TECHNICAL INFORMATION

TYPE NO FB55	TYPE Coffee vending machines	T.I.-NO 03/02				
SERIAL NUMBERS AFFECTED From machine number 120255016111	ISSUED BY Documentation/ Wittenborg Odense					
SUBJECT New Cup Holder		ISSUED FOR (X): <table><tr><td>Action</td><td></td></tr><tr><td>Information</td><td>X</td></tr></table>	Action		Information	X
Action						
Information	X

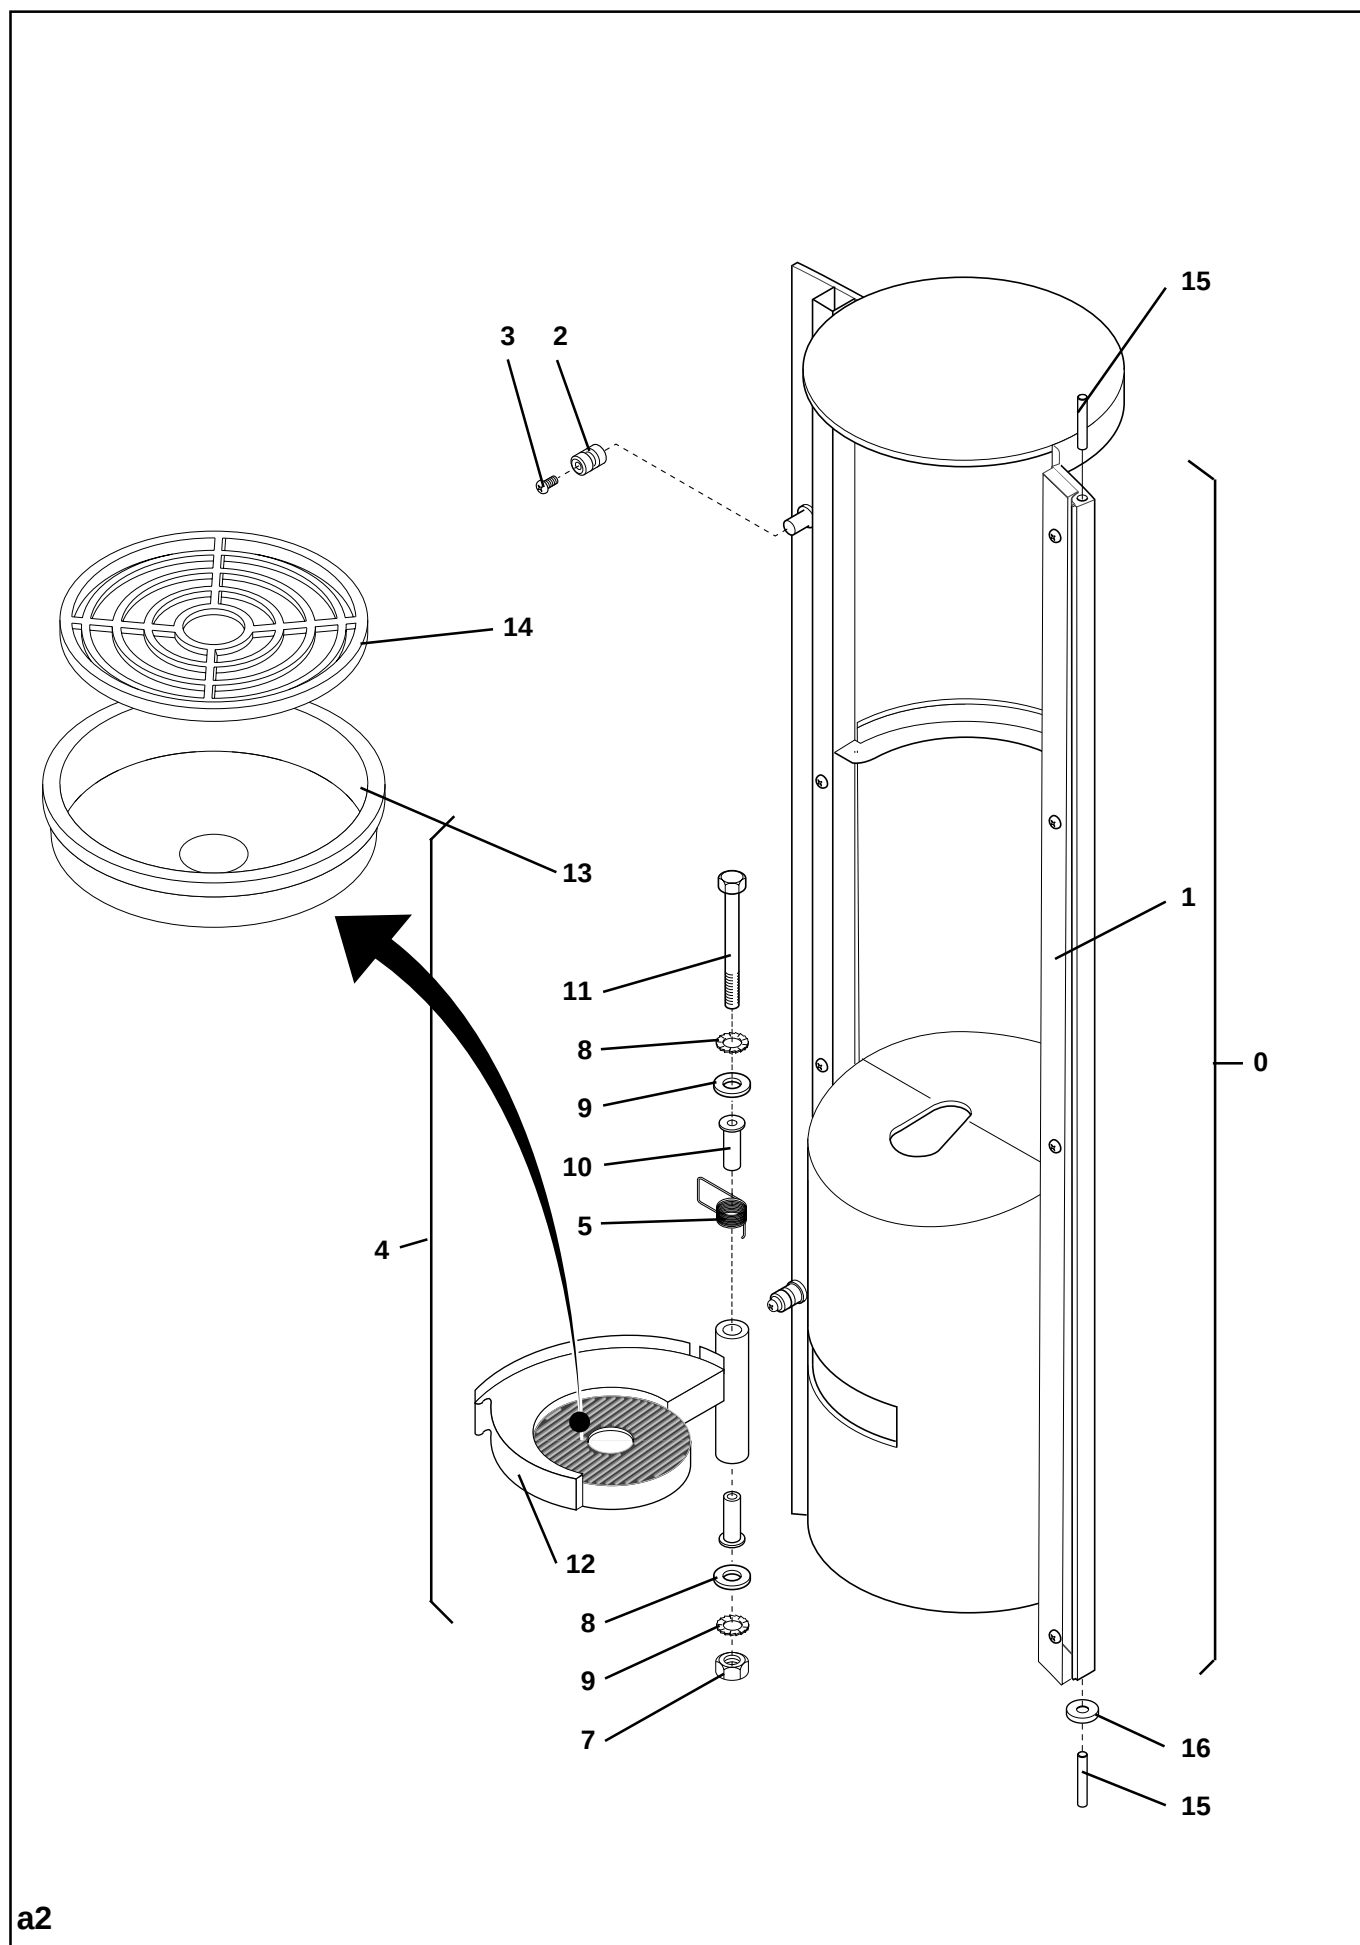
- From the above machine number all FB 55 machines in production will be supplied with the new cup holder.

The reflector holder on the new cup holder has been enlarged in order to ensure that the reflector is located closer to the transmitter resulting in the fact that the light beam from the transmitter is reflected back correctly.

- Improved registration of pot brew function.

- The new cup holder, part No 31010800, is not interchangeable with the present one, part No 35170800.
